To: T10 Technical Committee  
From: Rob Elliott, HP (elliott@hp.com)  
Date: 28 April 2004  
Subject: 03-240r2 SAS-1.1 Internal wide connector and cable

### **Overview**

A 4-wide internal cable and connector solution is being designed for connecting controllers (e.g. PCI cards) to backplanes. It is intended to be used in place of 4 SATA host connectors (on the controller) to 4 separate SATA cables to 4 SATA host connectors (on the backplane). This cable/connector is being proposed for both SATA II and SAS.

**Figure 1 — 4-wide connector picture (from Amphenol)**

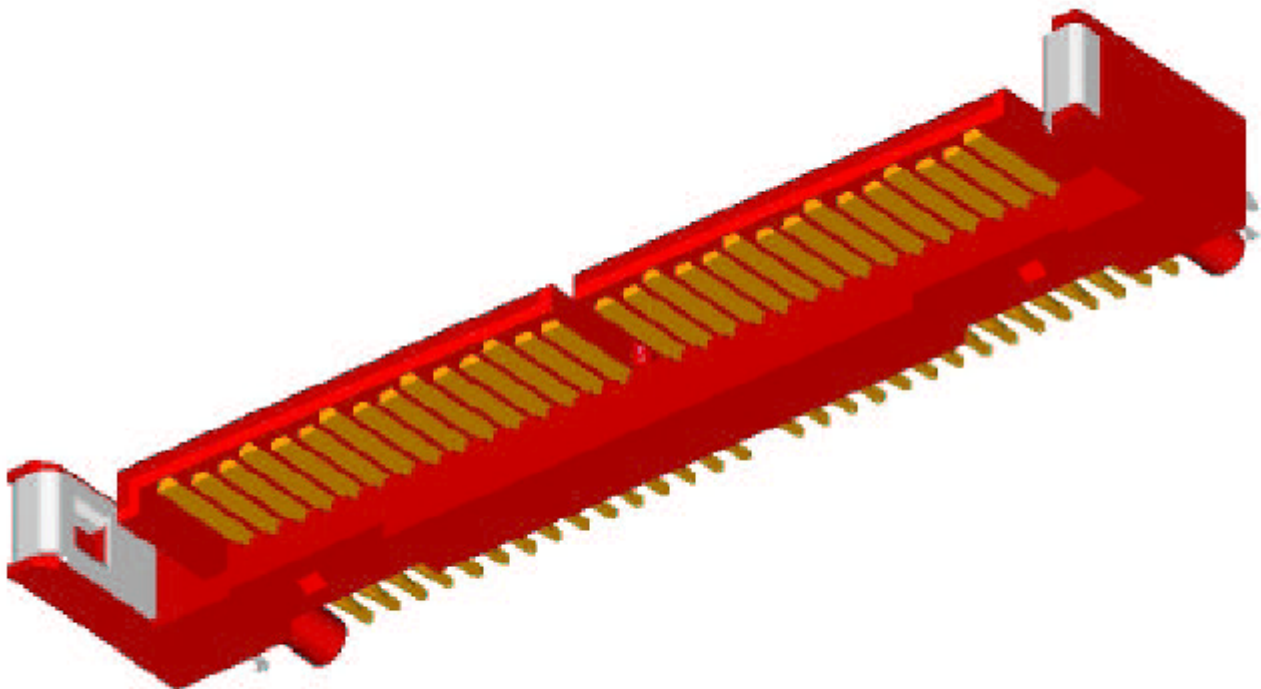
Editor's Note 1: Need an updated figure showing 6 sidebands. Better yet, want two 3D line

[drawing figures for inclusion in the plug and receptacle sections of the standard itself.](#)

**Figure 2 — [SAS cables and connectors - internal wide cabled environment](#)**

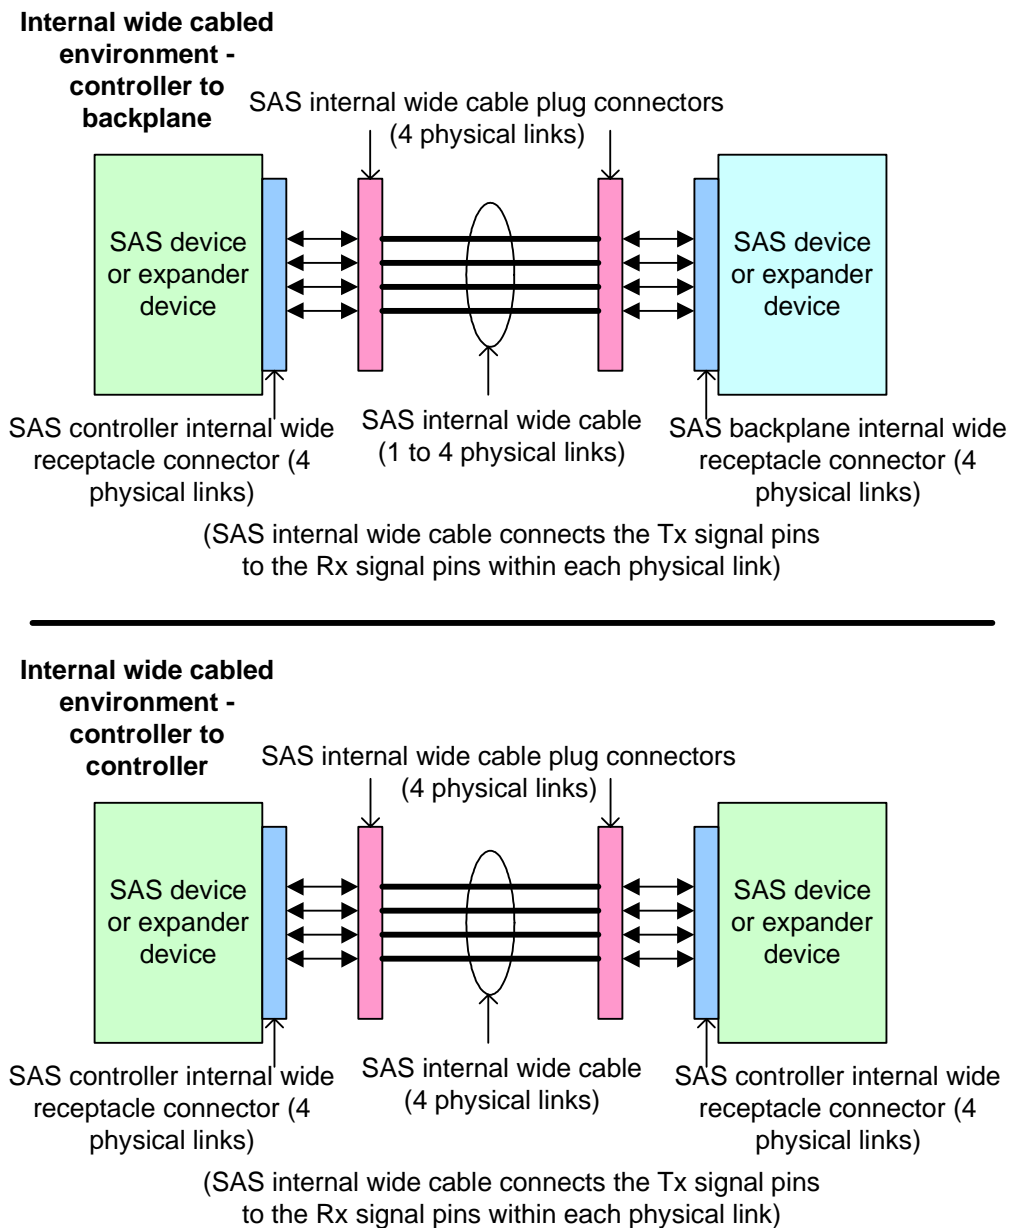
Revision 2 (28 April 2004) Changed G27 to G26 in table 999. Changed G297 to G29 in table 1000. Corrected table captions in figure 2. Fixed arrows in figure 4. Added wording options for sideband SGPIO requirements. Corrected SFF-8484 number in references and added SFF-8485.

[Figure 2 shows a schematic representation of the cables and connectors defined in this standard for the internal wide environment.](#)

[The internal wide connectors have different pinouts for the controller side and the backplane side so one side's Tx signals are attached to the other side's Rx signals. Two controllers may also be attached together, provided all four physical links are used, since one side's physical link 0 is attached to the other side's physical link 3.](#)

[The internal wide connector contains 6 sideband signals which are crossed when attaching a controller to a backplane but are not crossed when attaching a controller to a controller.](#)

Figure 3 — SAS internal wide cable attaching controller to controller

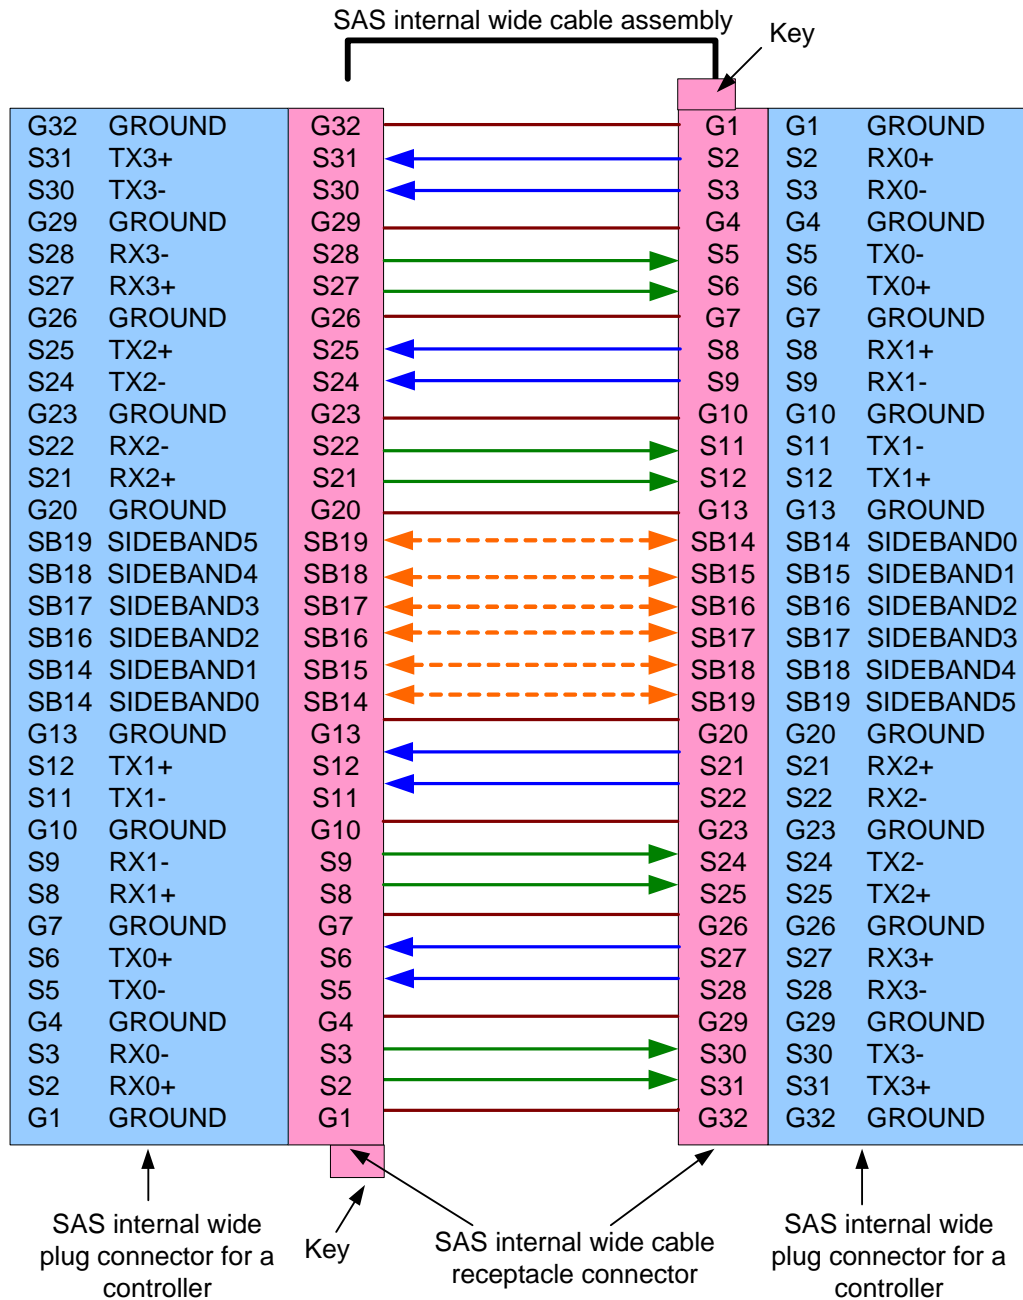
Figure 3 shows the SAS internal wide cable attaching two controllers.

NOTE 2 - For controller to controller applications, all four physical links should be used, because one side's physical link 0 is the other side's physical link 3. If both sides just used physical link 0, they would not communicate. The sideband signals are also crossed.

**Figure 4 — SAS internal wide cable attaching controller to backplane**

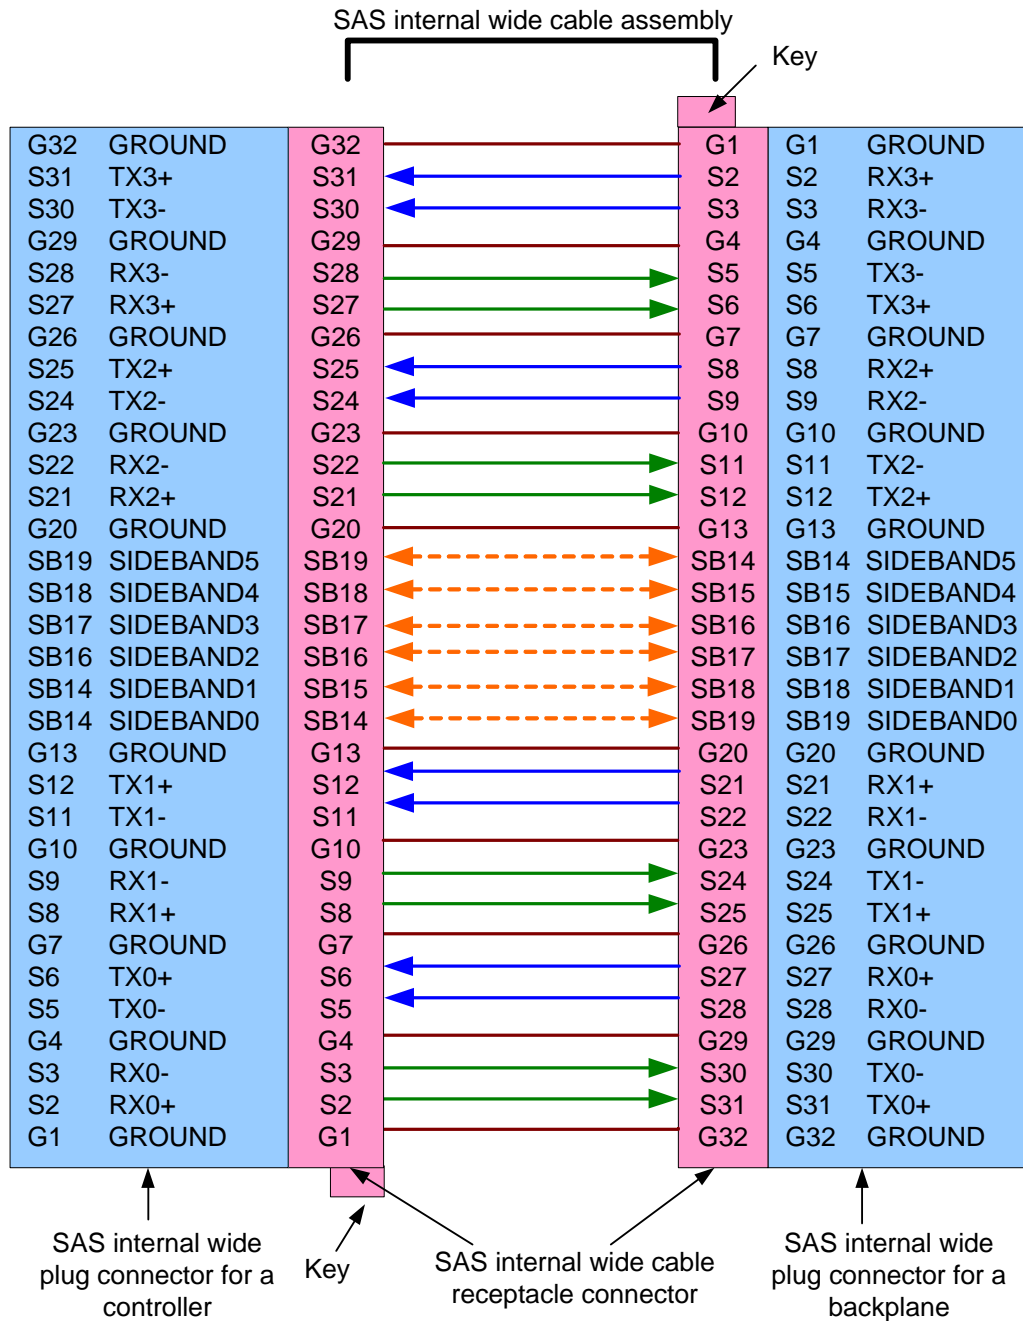
Figure 4 shows the SAS internal wide cable being used to attach a controller to a backplane.

NOTE 3 - For controller to backplane applications, up to four physical links may be used. The sideband signals are not crossed.
